Access Compliance Report

Public Rights-of-Way

Intersection ID: 27236		Main Street: BALLANTYNE CORPORATE PCross Street: BRIXHAM HILL AV		Location: NW					
ADA ID: 0E3BBF1BD27B		Ramp Type: BlendTrans1		Initial Pass/Fail: Fail		Overall Compliance: No		Severity Score: 1.25	
Codes/Mitigation Info/Possible Solution					Field Measurements/Component Compliance

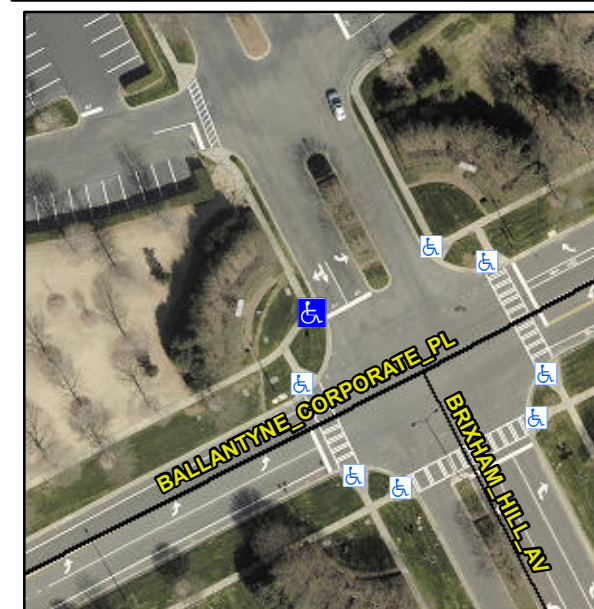
Compliance	Description	Data	Compliance	Description	Data
N/A	Ramp Length (in)	81.0	Yes	BlendTrans Slope (%)	3.9
Yes	Ramp Width (in)	49.0	No	BlendTrans XSlope (%)	4.0
N/A	Flare Type LT	N/A	N/A	Flare Type RT	N/A
N/A	Flare Slope LT (%)	N/A	N/A	Flare Slope RT (%)	N/A
N/A	Flare Traversable LT?	N/A	N/A	Flare Traversable RT?	N/A
N/A	Landing Length (in)	N/A	N/A	DWS Provided?	N/A
N/A	Landing Width (in)	N/A	N/A	DWS Contrast?	N/A
N/A	Landing Slope (%)	N/A	N/A	DWS Length (in)	N/A
N/A	Landing X Slope (%)	N/A	N/A	DWS Full Width?	N/A
N/A	Landing Curb? (Y/N)	N/A	N/A	DWS Offset (in)	N/A
N/A	Shared Landing?	N/A			
N/A	Gutter Ponding?	N/A	N/A	Gutter Slope (%)	N/A
N/A	Gutter Lip Ht (in)	N/A	N/A	Gutter X Slope (%)	N/A
N/A	Painted X Walk1?	No	N/A	Painted X Walk2?	N/A
	X Walk 1 Direction	To NE		X Walk 2 Direction	N/A
	X Walk 1 Width (in)	N/A		X Walk 2 Width (in)	N/A
	X Walk 1 Slope (%)	1.8		X Walk 2 Slope (%)	N/A
	X Walk 1 X Slope (%)	0.8		X Walk 2 X Slope (%)	N/A

N/A	Ramp inside XWalk1?	N/A	N/A	Ramp inside XWalk2?	N/A
	Road Slope (%)	0.8		Clear Space?	N/A
	Road X Slope (%)	1.8	N/A	Clear Space to XWalk (in)	N/A
N/A	Any Obstructions?	N/A	N/A	Storm Grate/Utility Hazard?	N/A
	Obstruction Type			Storm Grate/Utility Type	
		N/A			N/A
			Yes	Surface Condition? (G/P)	Good
			No	Curb Slope (%)	6.0

Remove & Replace Curb Ramp With Two New Directional Ramps or Equivalent.
